Network Video Recorder

Version: V4.40.015 build 200616

Release Note

(2020-6-16)

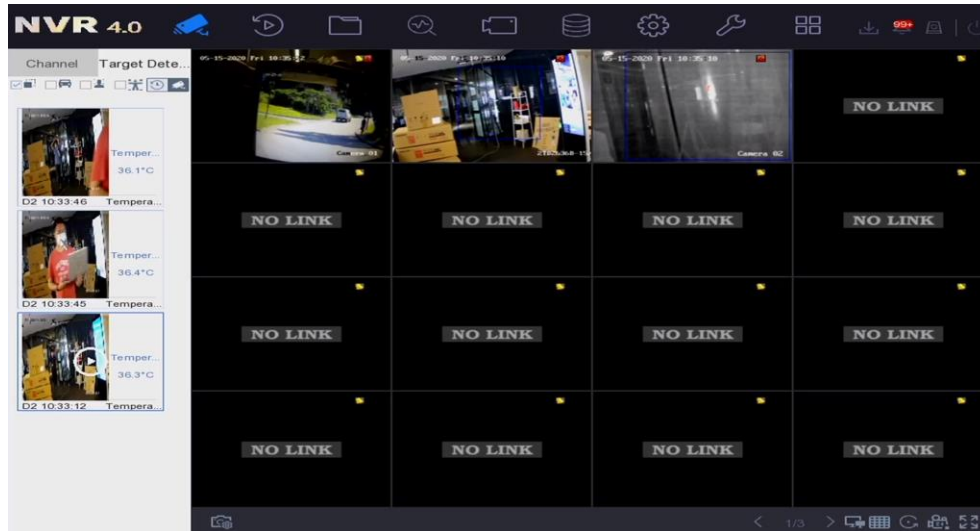
4. 【Support Hik-Connect / GuardingVision to scan NVR QR code to recover password】

1) Support local HC / GV scanning QR code and mailbox to recover password, Local GUI delete the recovery way of GUID and security issues; WEB still retain GUID, security issues and mailbox to recover password.

2) Only the NVR that has been bound to the HC / GV will display the option to scan the code to recover the password.

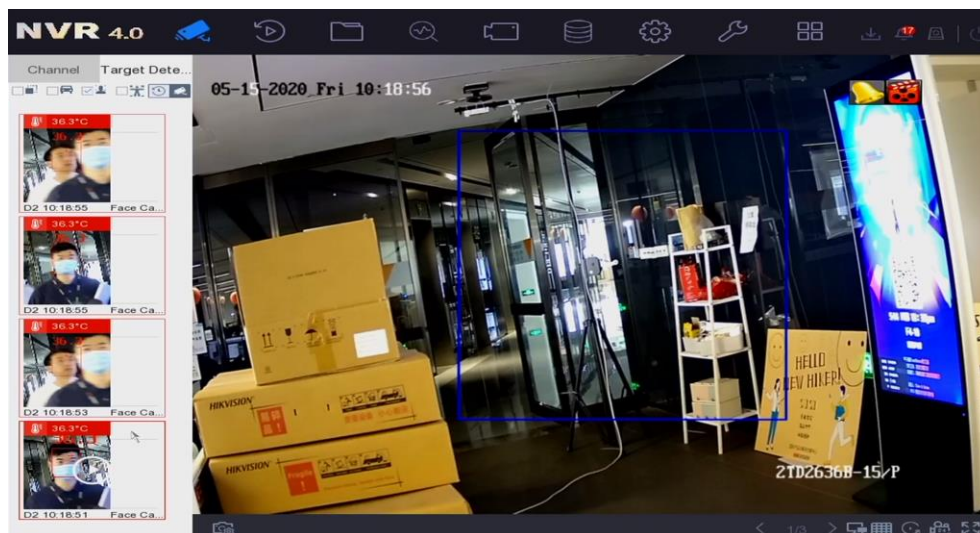
6. 【Support thermal camera temperature measurement alarm】

1) Support local target detection interface and 4200 to display real time temperature measurement alarm.

2) Support uploading pictures of visible light and thermal imaging to the platform software.

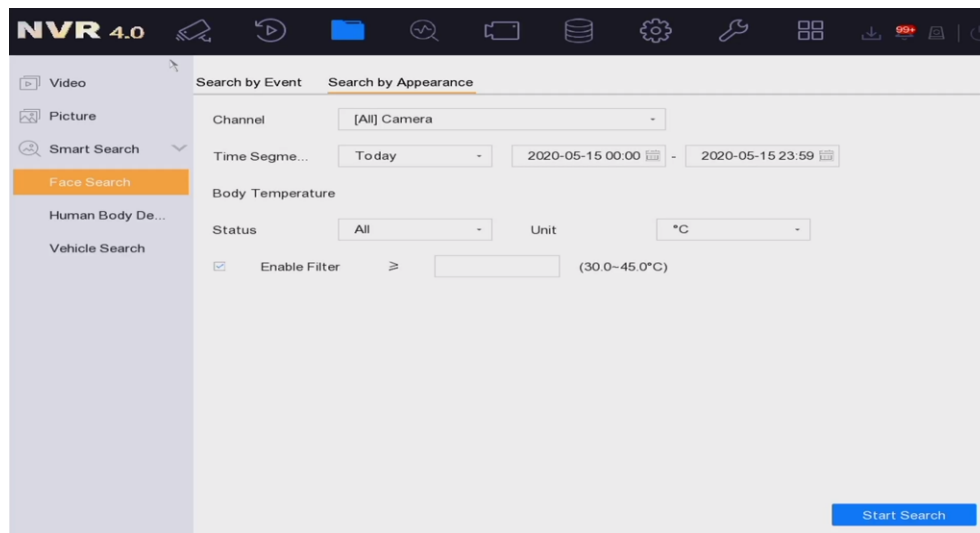
7. 【Support thermal camera face temperature alarm】

1) Support local target detection interface and 4200 to display real time face temperature alarm, abnormal temperature display red background, normal temperature display green background.

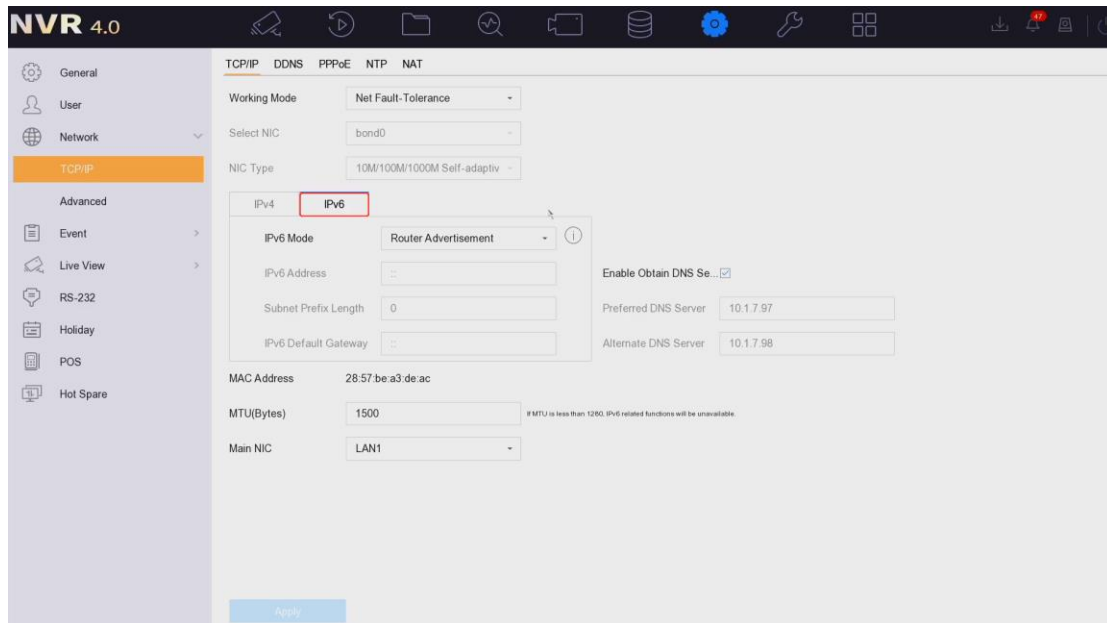
2) Support the voice announcement function of face temperature state linkage. NVR has two English pronunciations: abnormal temperature and normal temperature. Normal temperature is not linked by default, and abnormal temperature is linked by default.

3) Support local and 4200 to search face pictures according to body temperature status and temperature range, and support to display search results in specified temperature units.

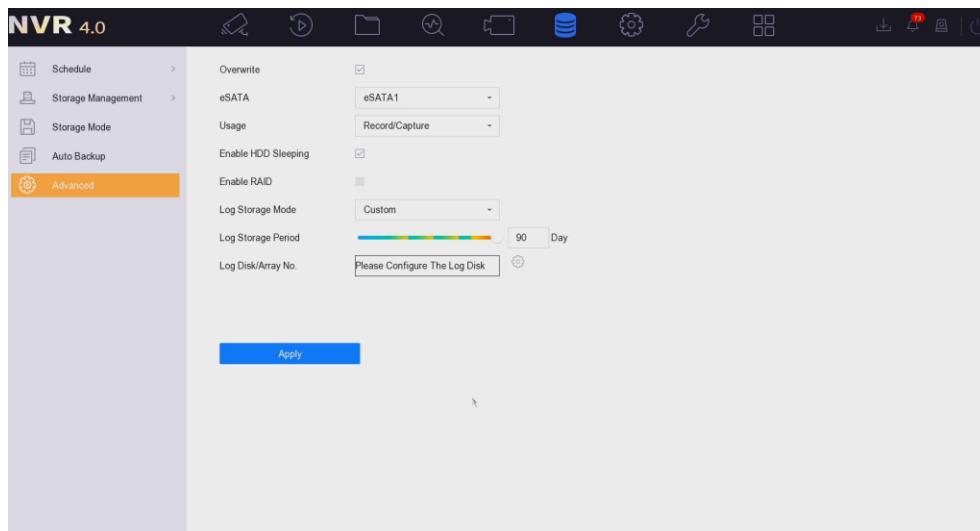
8. 【Support IPv6 network】

Support IPv6 network.

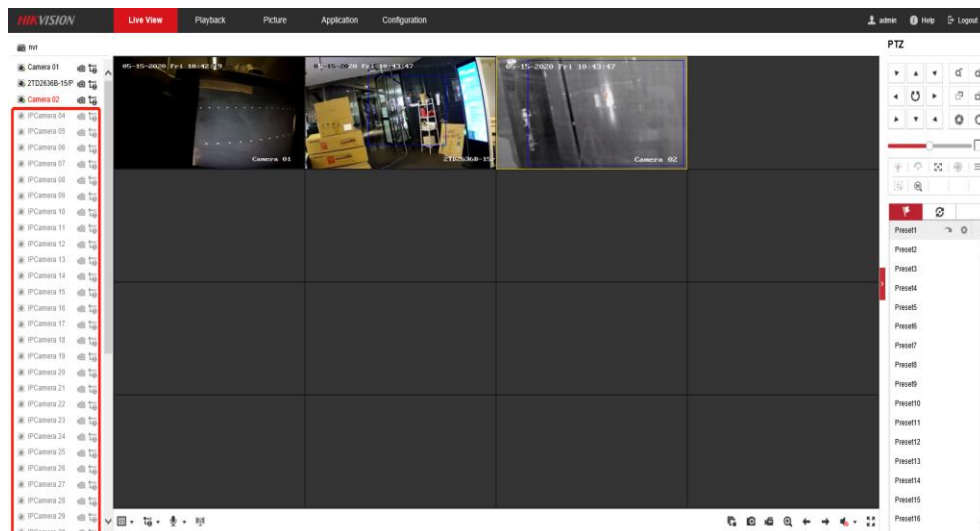
9. 【Increase log storage period】

1) Designate one HDD as the log HDD to store logs, and add log HDD configuration and management.

2) Support to configure log storage period from 1 to 90 days.

3) After the HDD is used as the log HDD, the abnormality of the HDD, the full HDD, and the absence of the HDD will trigger the abnormal alarm of the log HDD.
